RE: Willow Pass Generating Station
Application for Certification 08-AFC-06

**Response to
CEC Data Request 48 (Landscaping)**

**Application for Certification
(08-AFC-6)
for
WILLOW PASS
GENERATING STATION
Pittsburg, California**

48. *Please provide a draft landscaping plan that would mitigate visual impacts from the project at the selected KOPs.*

FIGURE 1

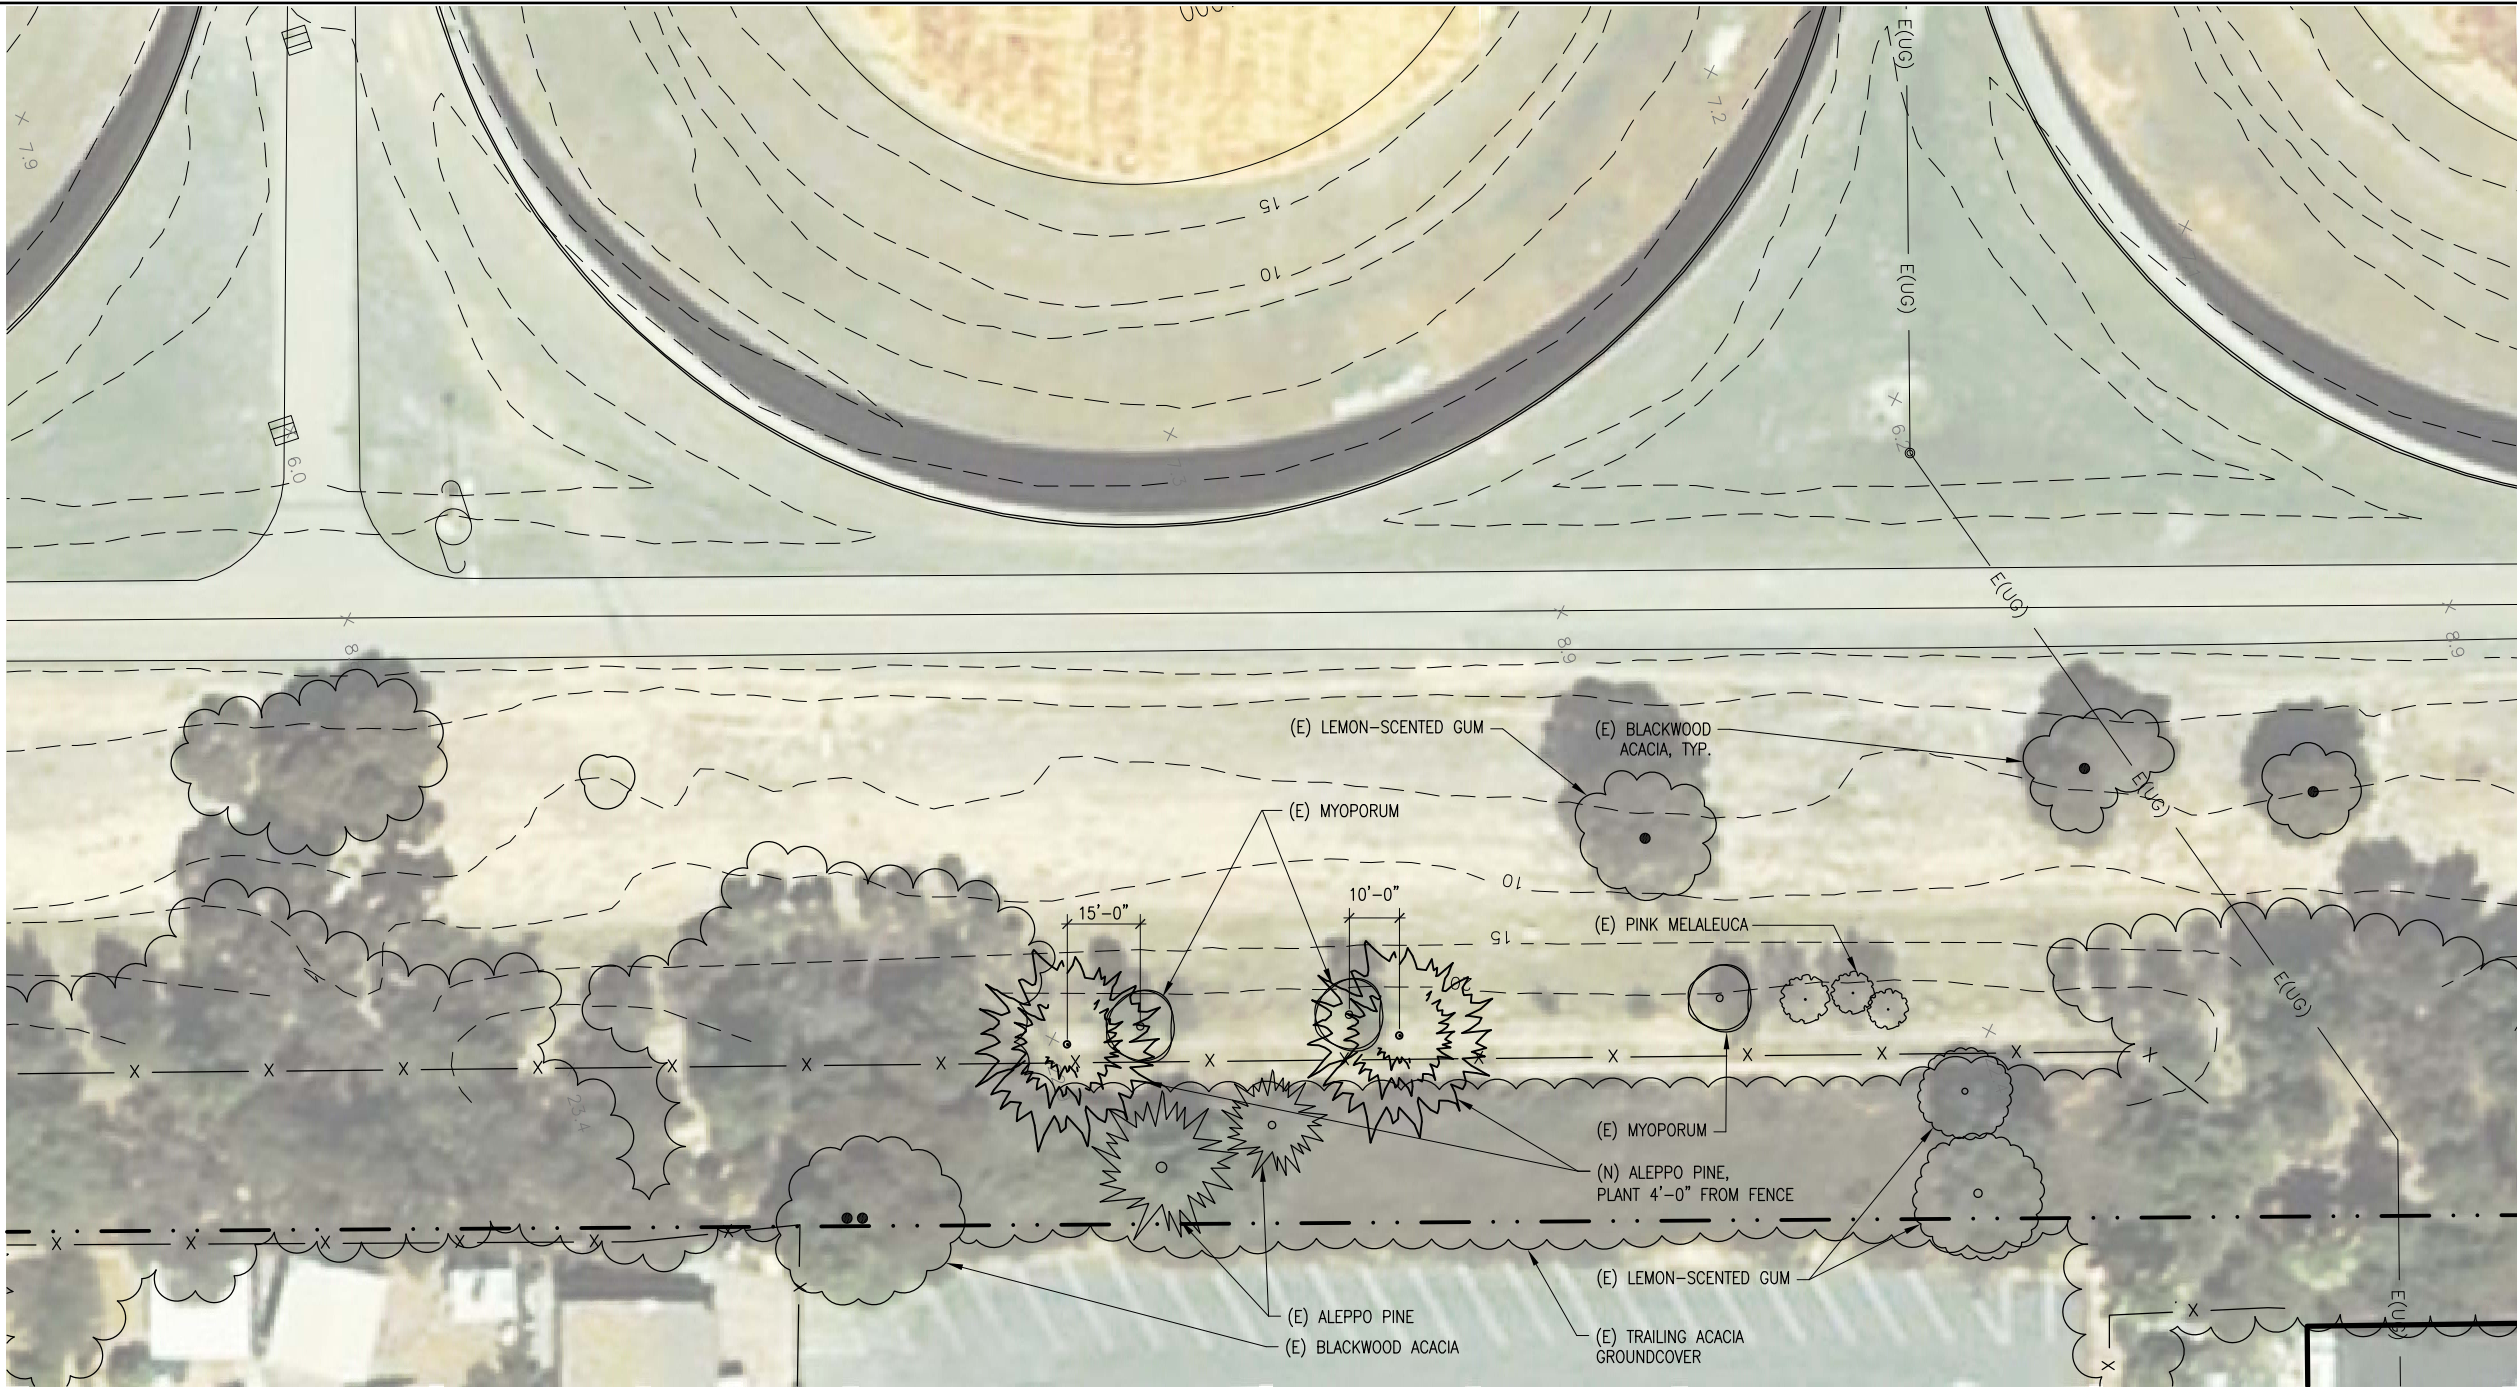
A number of large cooling water discharge tunnels owned by Mirant Delta and used in the operation of the existing PPP are located directly below the planting strip along the fence in this area (refer to Figure 1 in Appendix C for their location), described further below.

The open space identified by the City in KOP 1 exists due to the presence of four underground discharge tunnels that support the operation of PPP Units 5 and 6. The tops of these reinforced concrete tunnels are at an approximate depth of 8 to 12 feet below the existing grade. The diameter of the tunnels range from approximately 7 to 10 feet. These reinforced concrete tunnels were constructed in the 1960s and were not designed or constructed to support the weight of significant additional surface loads. Although a few trees currently exist in the area of the tunnels, there are unit operations concerns about installing new trees on top of and/or near the primary discharge tunnels of Pittsburg Units 5 and 6. In the case of a Canary Island date palm tree, the expected weight of a mature palm tree can approach 15 tons, and this load would be concentrated in the area of planting because of the natural root system of these palm trees. The majority (85 percent) of the date palm root system is typically distributed within a spherical area with an

Because of the design and age of the reinforced-concrete tunnels, the weight of the palm trees, and the potential of the palm tree root system to penetrate into the discharge tunnels and interfere with existing equipment used for monitoring temperature, volume, and water quality of the discharge, it is not feasible to plant palm trees or other similar trees on top of or in the immediate vicinity of the discharge tunnels, due to substantial risk of damage and/or blockage of the tunnels, which would interfere with the operations of PPP Units 5 and 6.

Therefore, rather than new plantings, there are existing oleander shrubs directly north of the PPP fenceline that could provide additional screening (See Photo 1 above). The existing oleander shrubs appear to be regularly thinned and trimmed at the level of the top of the fenceline and along their sides, thus currently providing minimal screening. This trimming is also limiting the foliage density of the shrubs. Oleander shrubs, even in their natural conditions, develop good, dense foliage on their outside; however, they have only sparse leaf growth and twigs inside of their crown. When the outer foliage is clipped away, the shrubs temporarily lose their screening qualities. If the trimming of the oleanders is stopped, they are regularly lightly irrigated on a regular basis; and soil around them is fertilized; then they will quickly develop dense new foliage, and provide a solid tall evergreen screen. Without further trimming, this "oleander hedge" can reach up to 20 to 25 feet in height in several years. The tallest oleanders in California have exceeded 30 feet in height. The shrub is considered to be fast growing under normal conditions, and its growth rate is up to 36 inches per year.

KOP 6: LANDSCAPING PLAN

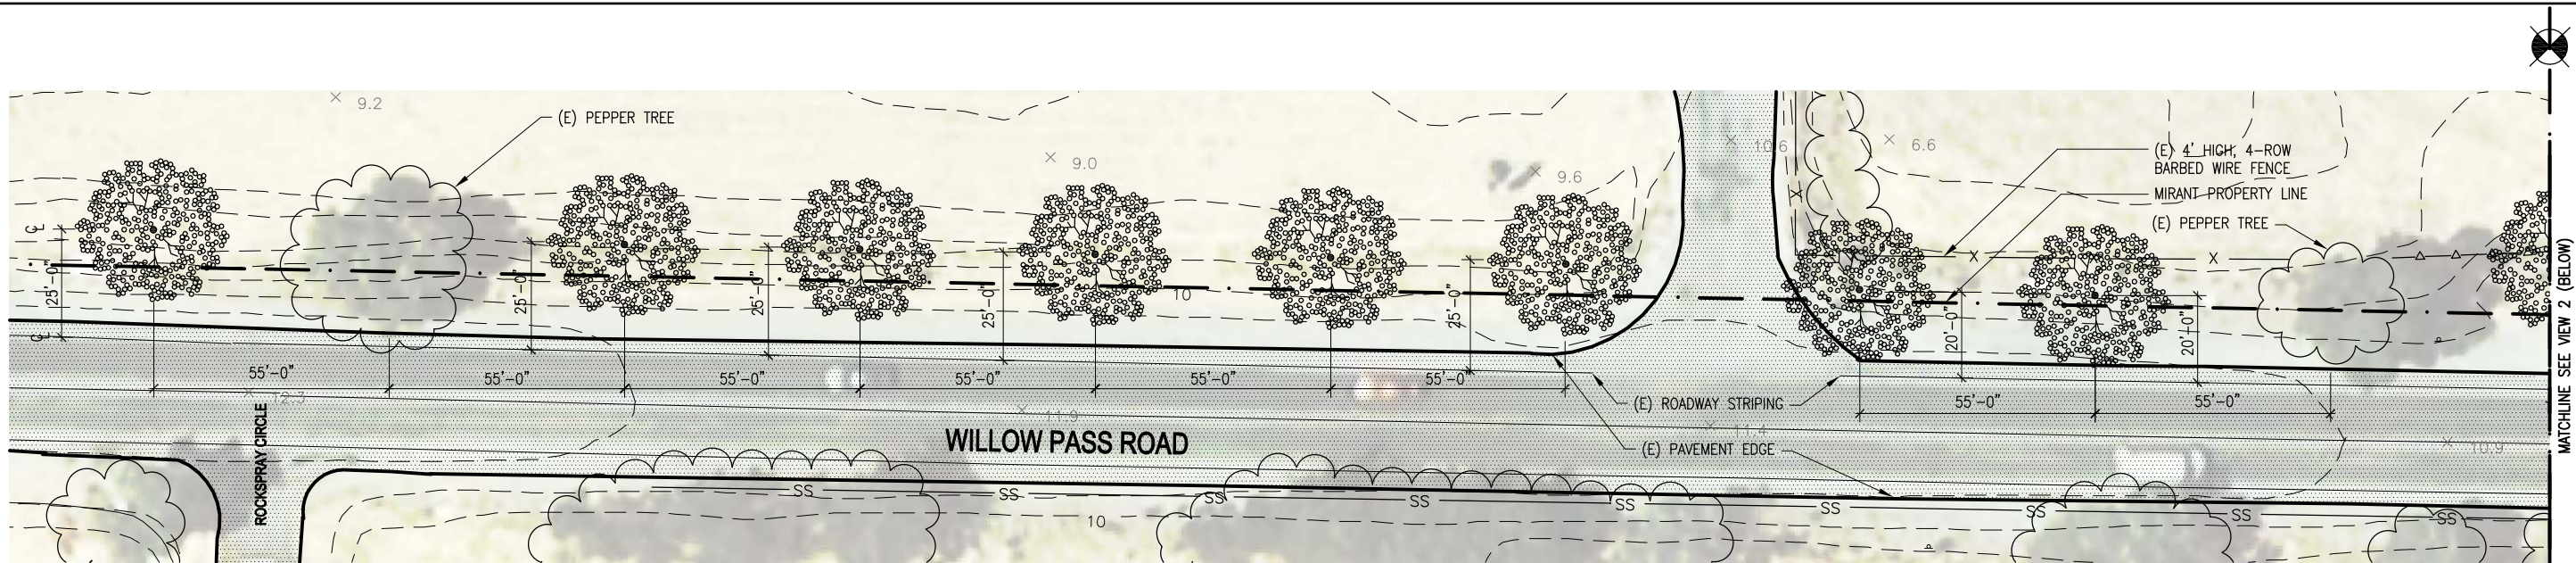
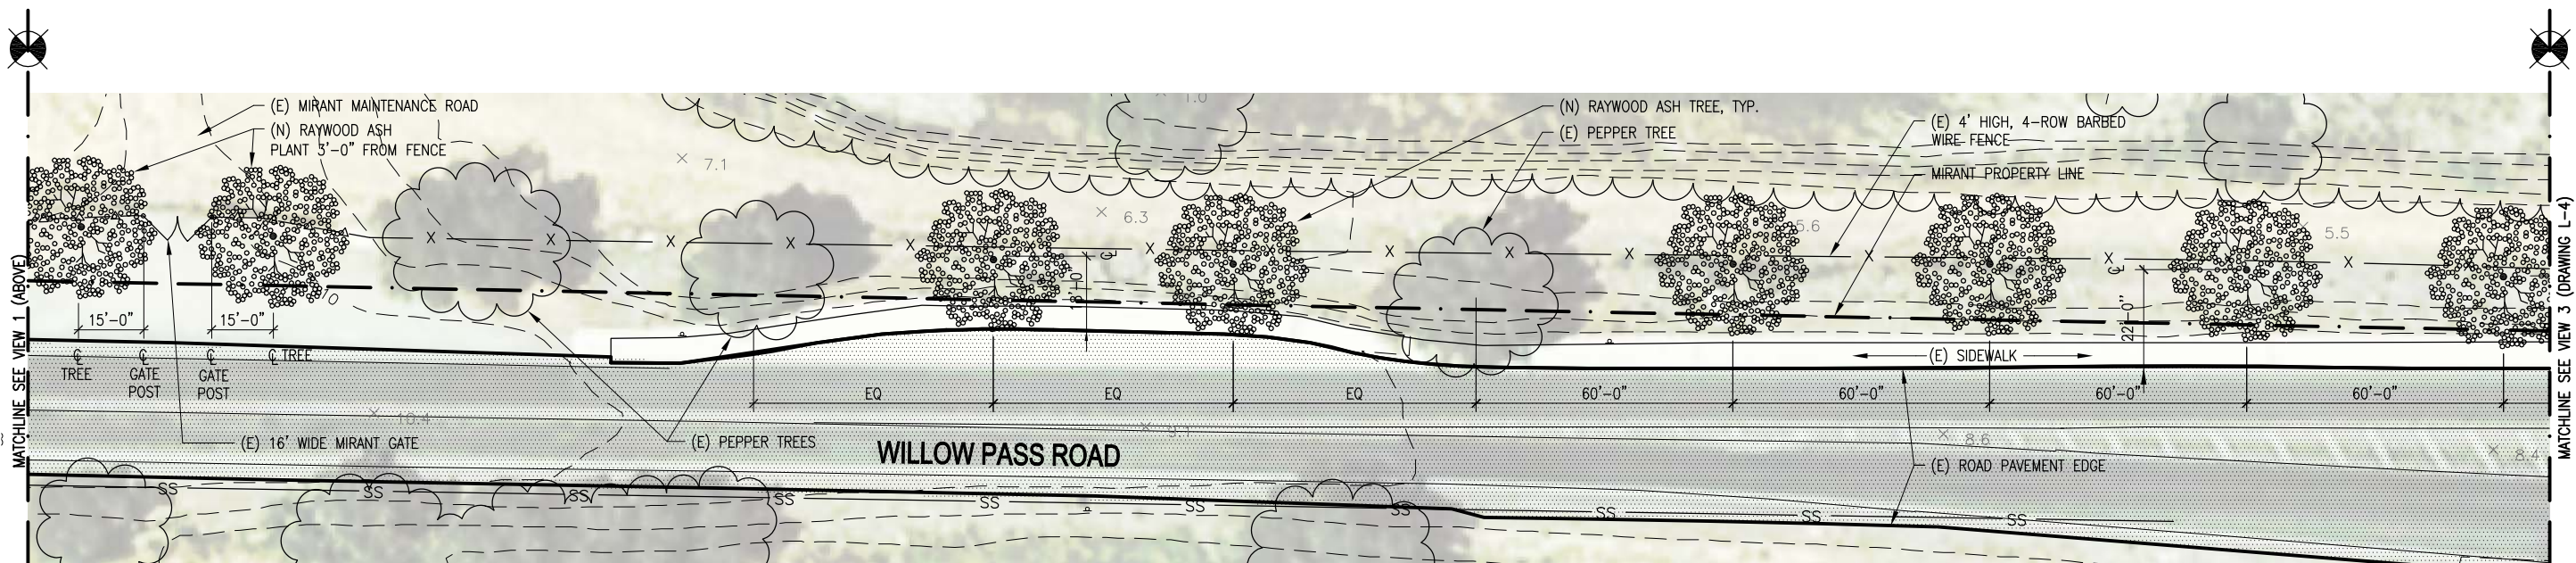
The City of Pittsburg recommendation for the landscaping along the northern side of Willow Pass Road from Rockspray Circle (1215 Willow Pass Road) to the western edge of the PG&E transmission line corridor is to supplement the existing scattered pepper trees with new, evenly spaced trees. Their letter recommends placing pepper trees approximately every 60 feet along the north side of the road.

There is a potential for the pepper trees to become invasive, therefore, upon further communication with Kristin Vahl and the Pittsburg Department of Public Works, the City suggested the use of Raywood ash or Chinese pistache instead of pepper trees. Because the area where these trees would be planted would be primarily near or within a roadside swale, Chinese pistache may not be appropriate to provide sufficient screening because of its small size. This species is also not very tolerant of inundated soils.

Raywood ash, which is a much larger tree, would be capable of providing quick screening. Raywood ash is also well adapted to adverse environmental conditions, which may occur at this site, and which may include both seasonal inundation in the winter and substantial drought conditions during the hot and windy summers. At the request of the City, proposed new trees have been placed further away from Willow Pass Road than the existing trees to prevent their encroachment into the roadway. Proposed trees have been set back from 18 to 25 feet (as measured from the Willow Pass Road westbound lane pavement striping on the north side). The distance of existing California pepper trees from the roadside edge varies from 10 to about 18 feet. The proposed trees would be planted on the outside of the existing Mirant Delta fence. Even though they would be set back further from Willow Pass Road than the existing trees, they would still be planted on Mirant Delta's property, because the fence is set from 10' to 15' back from the actual property line (which is closer to Willow Pass Road than the fence). The areas on the Mirant Delta side of the fence do not appear appropriate for planting because in some cases there is an existing road, in other cases there are wetlands located in the area (Photo 4).

Because of the drought resistance of Raywood ash trees and the proximity to the water table, the proposed trees could survive with manual or truck irrigation during the first year. There are no utility lines indicated on any of the drawings available at the time of this design that would interfere with the tree planting. The landscape contractor, however, would be required to contact an appropriate utility location company prior to any digging.
